**EB-2022-0200 Enbridge 2024 Rebasing Application
Pollution Probe Interrogatories to Applicant**

**Enbridge Gas Inc.
2024 Rebasing**

POLLUTION PROBE INTERROGATORIES

Reference: Figure 4 Exhibit 1, Tab 10, Schedule 5, Page 15

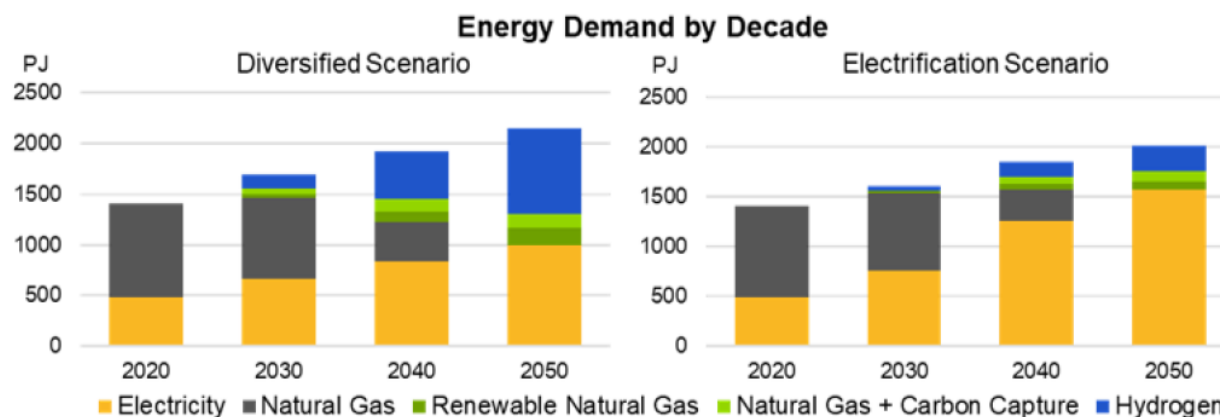
- Please provide a table (or source spreadsheet) showing PJ and percent of total by energy type shown in legend (for each time period and scenario shown in the table).

- For the hydrogen shown in each scenario please indicate the expected source of the hydrogen and whether it would be transmitted/distributed via a pure hydrogen pipeline or a blend. If it is a blend, please indicate the percent blending for each scenario and by time period shown in the graph.

- Please provide the expected lifecycle emissions (e.g. lifecycle Kg CO₂e per PJ). for the hydrogen included in Figure 4 above. Please provide calculations or references that provide the source of the emission intensity assumptions.

- Please provide details on how carbon capture would occur (e.g. technology/process for capture and where would the captured CO₂ be stored) in the scenarios Enbridge has identified.

- Does Enbridge have a reference on the potential geological sequestration of CO₂ in Ontario? If yes, what is the total in tonnes of CO₂ storage available? Please provide the report or related references.

- Please explain the difference between “natural gas” and “natural gas with carbon capture” outlined in the Energy Transition scenarios provided by Enbridge.

- For the “natural gas with carbon capture” scenario, please explain what “carbon capture” assets (if any) Enbridge would expect to be in rate base as part of the regulated utility business.

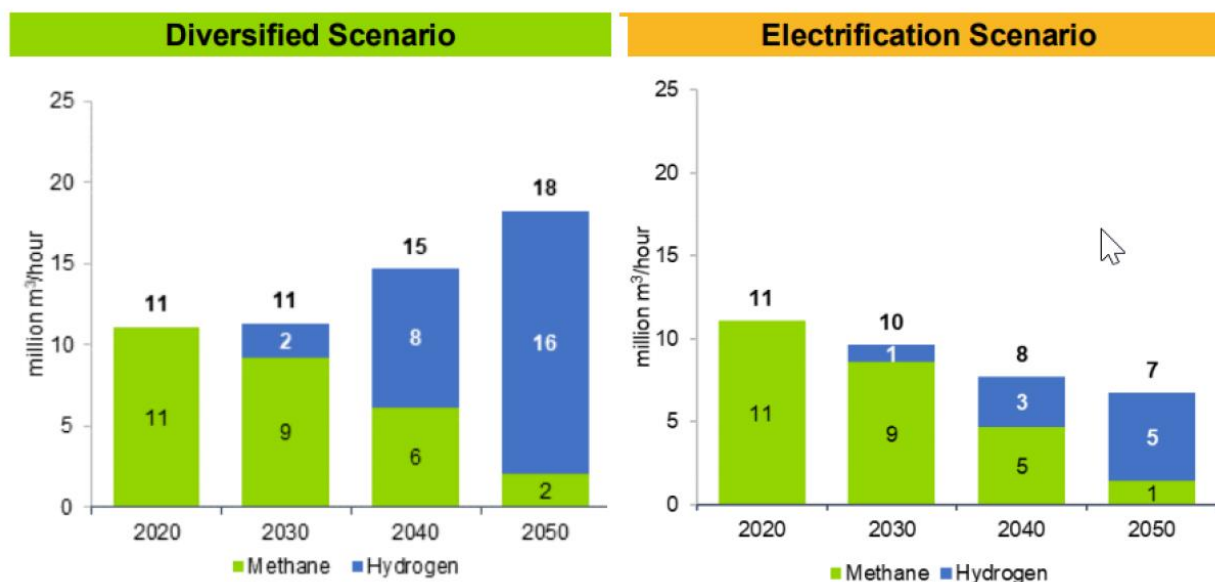
In EB-2022-0203 Enbridge indicated that the Project was not assessed as an individual project with respect to its greenhouse gas ("GHG") emissions impacts. However, the emissions associated with these facilities will be included as part of Enbridge Gas's overall GHG emissions inventory and will be addressed as part of the Company's overall GHG strategy to reduce emissions [EB-2022-0203 Exhibit I.PP.10b]. Please explain which budget line item in the current filing includes funding to offset emissions to these kinds of projects and provide a list of the projects where emissions are estimated to be mitigated.

Reference: “In the Diversified scenario, hydrogen plays a large role in building heat. Since hydrogen is less energy dense on a volumetric basis than natural gas, the volumetric peak demand in the Diversified scenario increases...” [Figure 4 Exhibit 1, Tab 10, Schedule 5, Page 15]

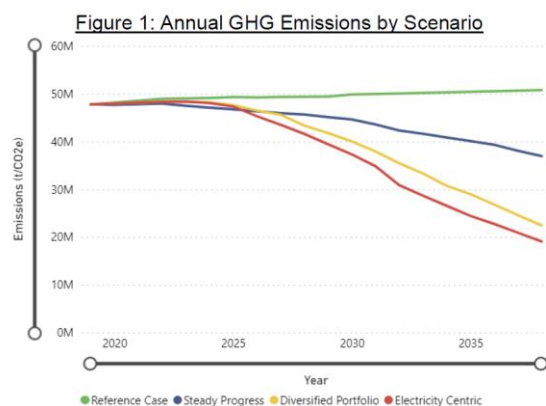
- a) Please show the calculation comparing the volume of hydrogen required for 1 MJ compared the volume of natural gas required for 1 MJ of energy.
- b) Please confirm what volume of hydrogen (as a gas in a pipeline) would be required to replace 1 cubic meter of natural gas to provide the same amount of energy.

Reference: Figure 1, Exhibit 1, Tab 10, Schedule 5, Page 9

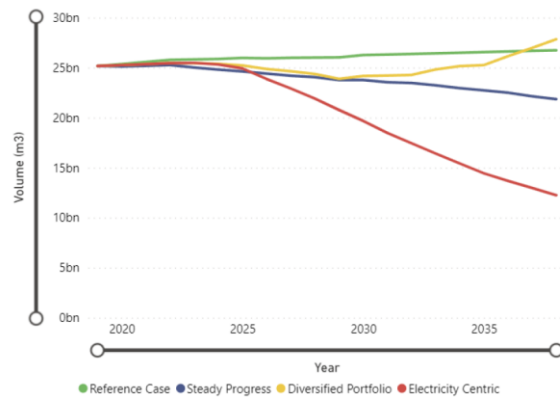
- Please replicate Figure 1 with PJ on the y-axis and all other information the same.
- In 2028 what is the decreased use in natural gas (units and %) per scenario compared to the 2024 Reference Case?
- Please provide a table showing the volume and percent by year of low carbon gas for each scenario.
